**AIRWORTHINESS DIRECTIVE**

№ 2017-322-05

**Applicability –RRJ-95 Aircraft**

**DECISION NO. RRJ0000-OR-470-1062**

Figure 26. Left fitting, right opposite.

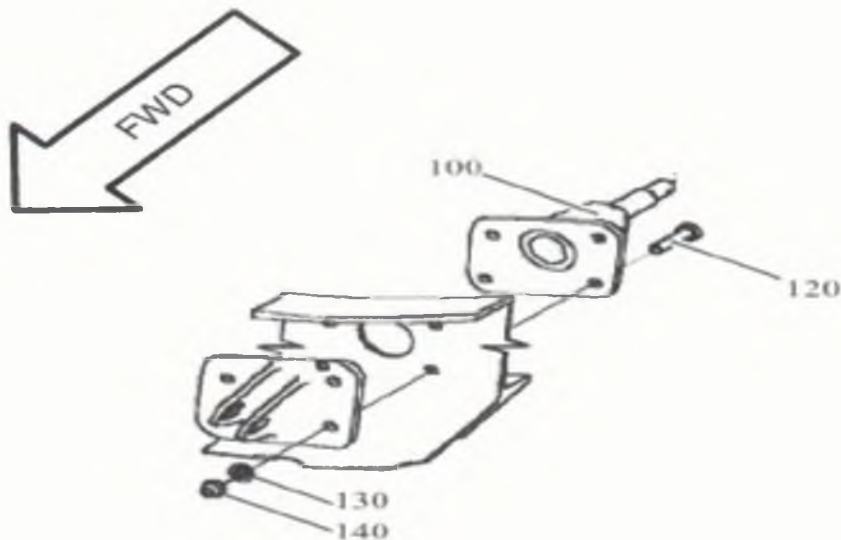
- 1.18. Remove brackets from the frame 58.

**NOTES:** Remove and save tie-down fitting.

- 1.19. To perform a visual inspection for damage.  
In case of cracks detection A/C operation must be stopped, information immediately sent to SCAC.

Figure 27. Spotdrill

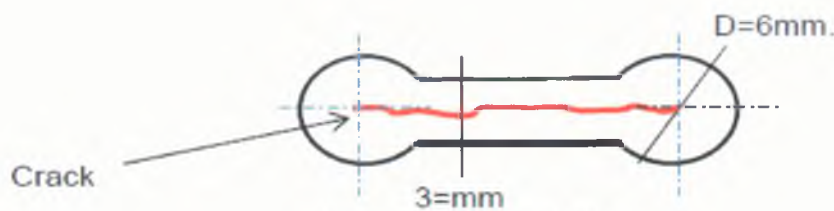
1.20.1. Begin to drill  $D=6\text{mm}$ , mill 3 mm with oval burr see fig.27.

**NOTES:** To ensure the roughness of the working surfaces not less than Ra 1.6. It is not allowed to have scuffs and score mark on the surfaces.

Figure 28. Splice plate/001

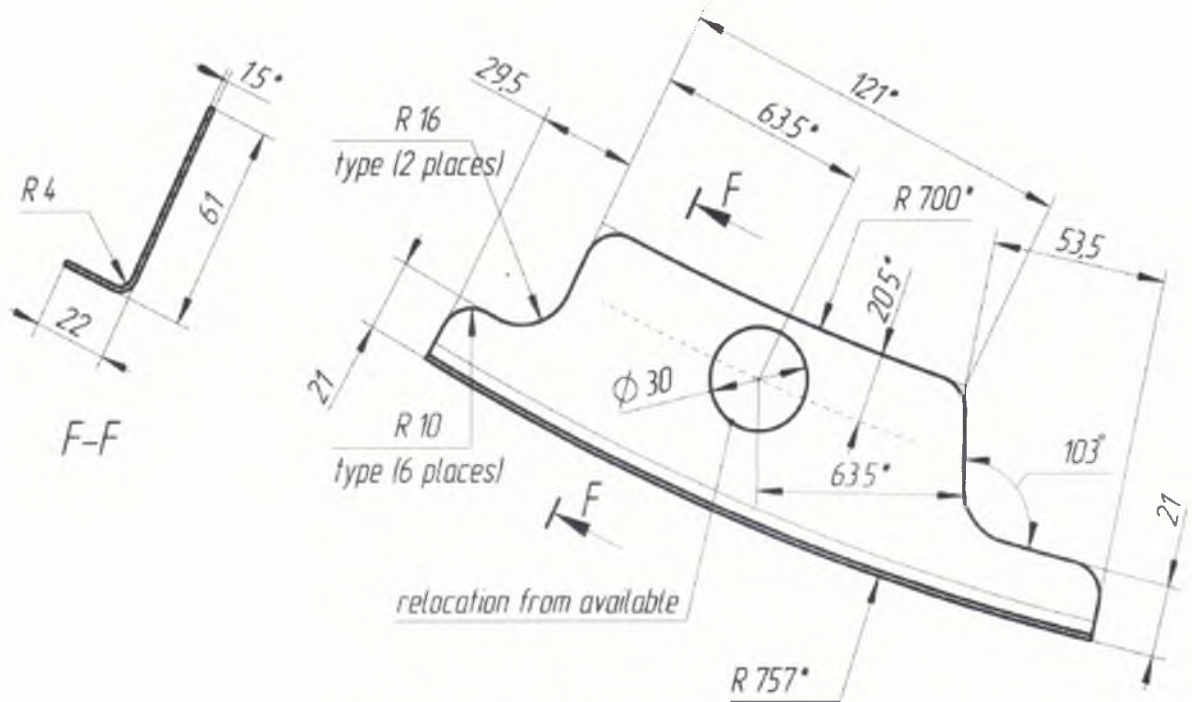
1.20.3 To produce splice plate of 12X18H10T thickness 1,5 mm see fig. 29,30, surface roughness Ra3.2, chemical passivation. The splice plate should be manufactured from metal sheet without additional treatment.

**NOTES:** Instead of Alodine 1200 is possible to use enamel ЭП-0215, 076 and ЭП-140. Do not apply enamel and primer on the splice plate with chemical passivation. Installation blind rivets with countersink  $90^\circ$ .

Figure 29. Splice plate/002

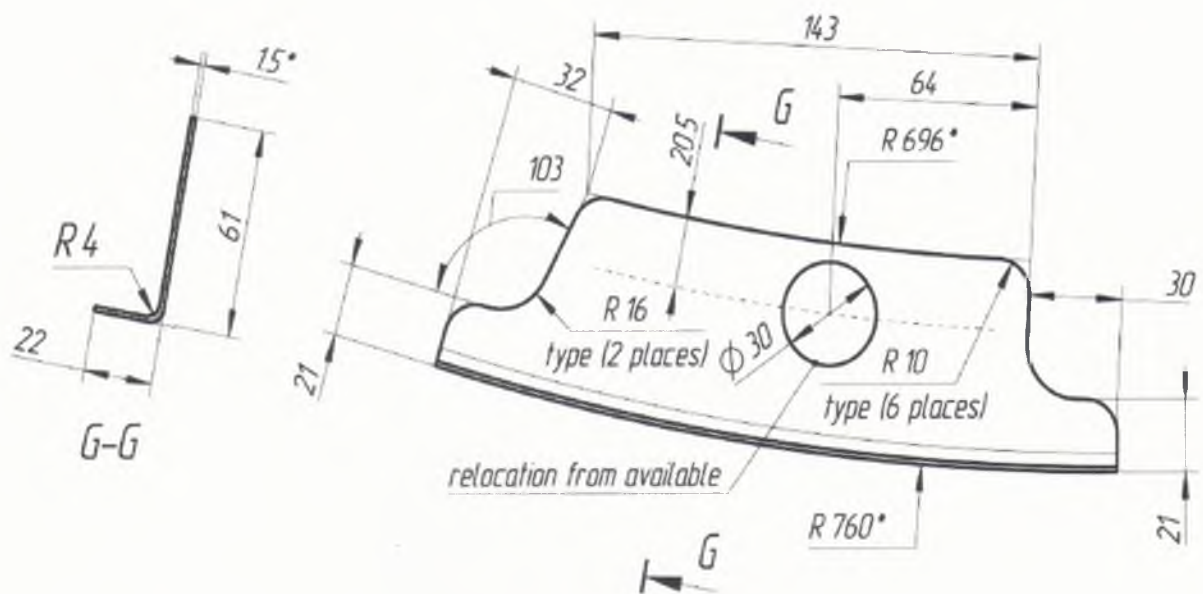
1.20.5 Align the holes from the frame on the splice plate for mounting the brackets (pos. 100) see fig.35 and machined bolt holes (pos. 120) 6-24 Ц OCT 1 31103-80 per H12 with roughness Ra3.2.

Figure 30. Installation of the splice plate. Front view

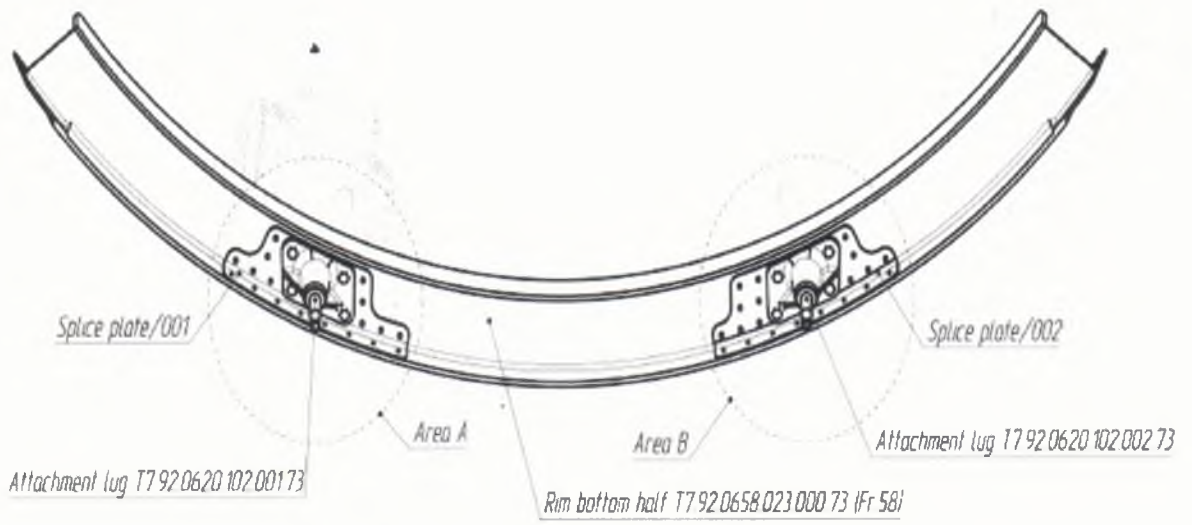
1.20.4 Perform the repair with the sealant RRJ-070-ГВ or alternative see Fig. 31,32,33,34.

Figure 31. View A

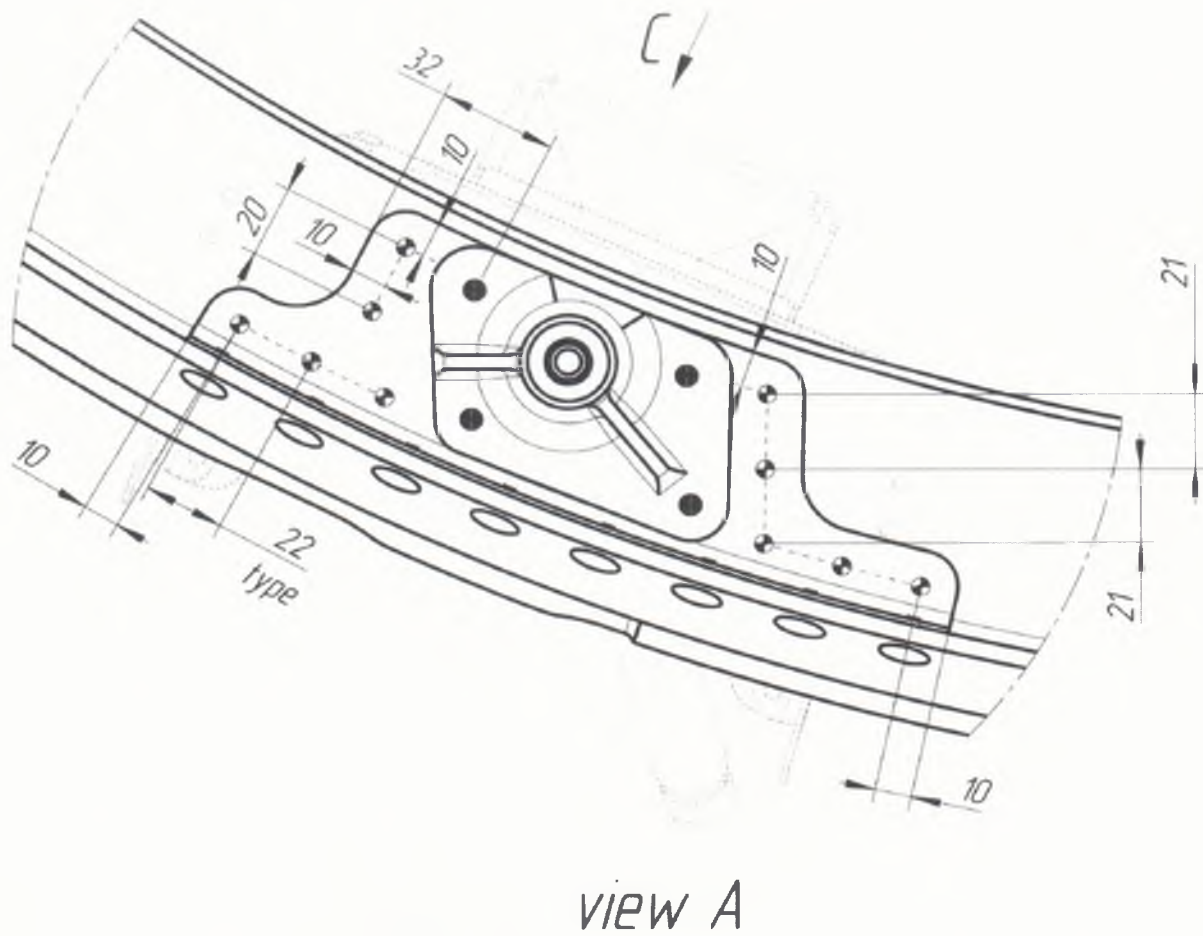
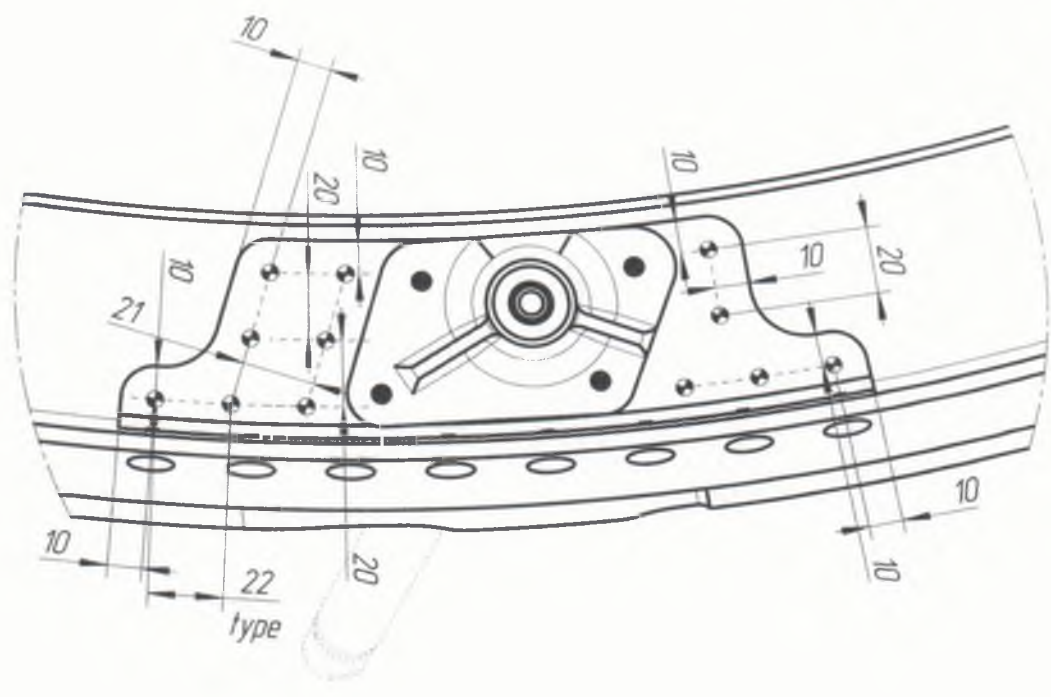
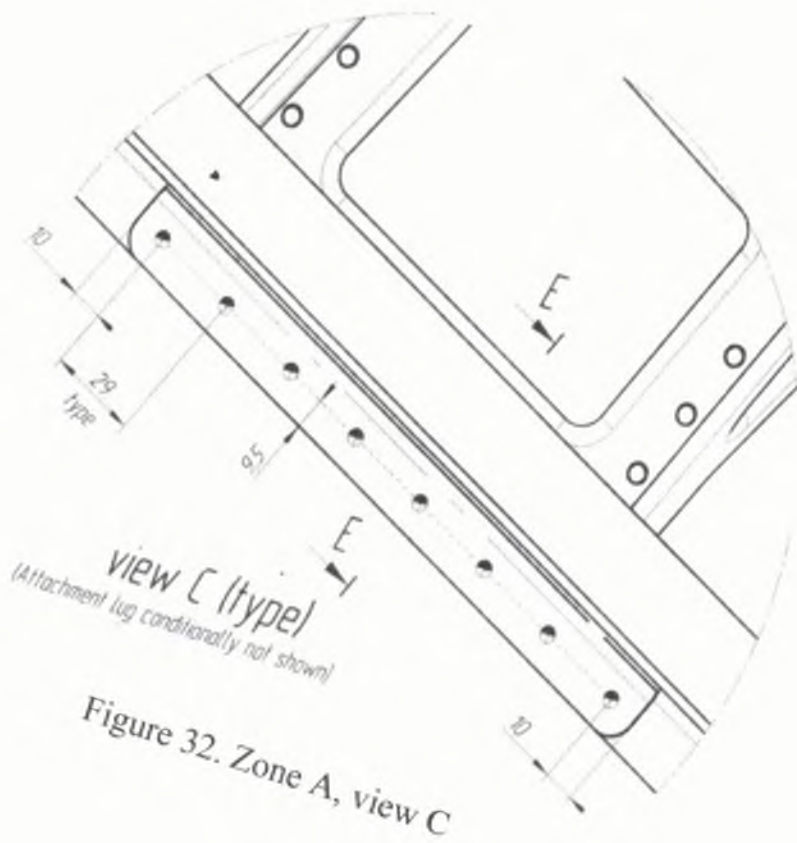
- 4-11-Ан.Окс-ОСТ 1 34047-80 on the Web
- 4-11-Ан.Окс-ОСТ 1 34047-80 on the Belt
- 6-24 Ц ОСТ 1 31103-80 for mounting the brackets

Figure 34 Left fitting, right opposite.

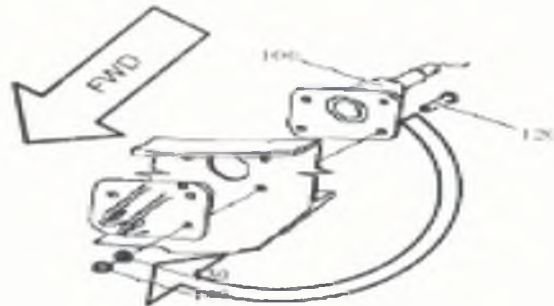
- 1.21. To install brackets on the previous disassembled bolts and washers 8qty. (4 qty. per each attach brackets). Bolts pos.120 is needed to open out on 180 degrees see Fig.34.

**NOTES:** Torque value for nut M = 7,1 H.M.

Fasten bolts and nuts with a primer ЭП-076 and enamel ЭП-140.

Figure 35

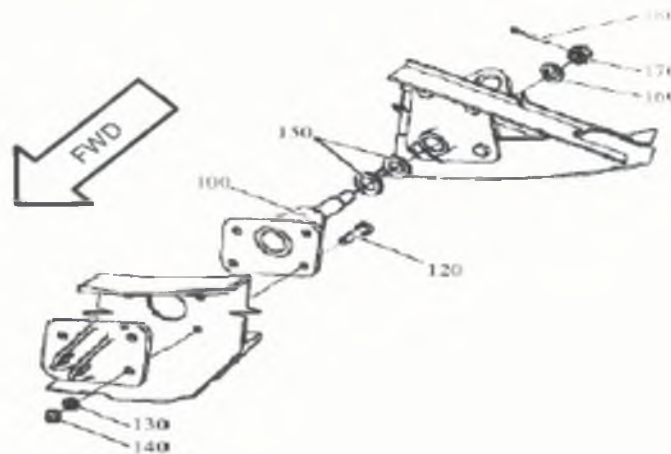
- 1.22. Remove the washers (150) from the pin (100) for temporary installation Section F6 for regulation F6. See Figure 35.

**NOTES:** Adjusting Washer can also be used on.
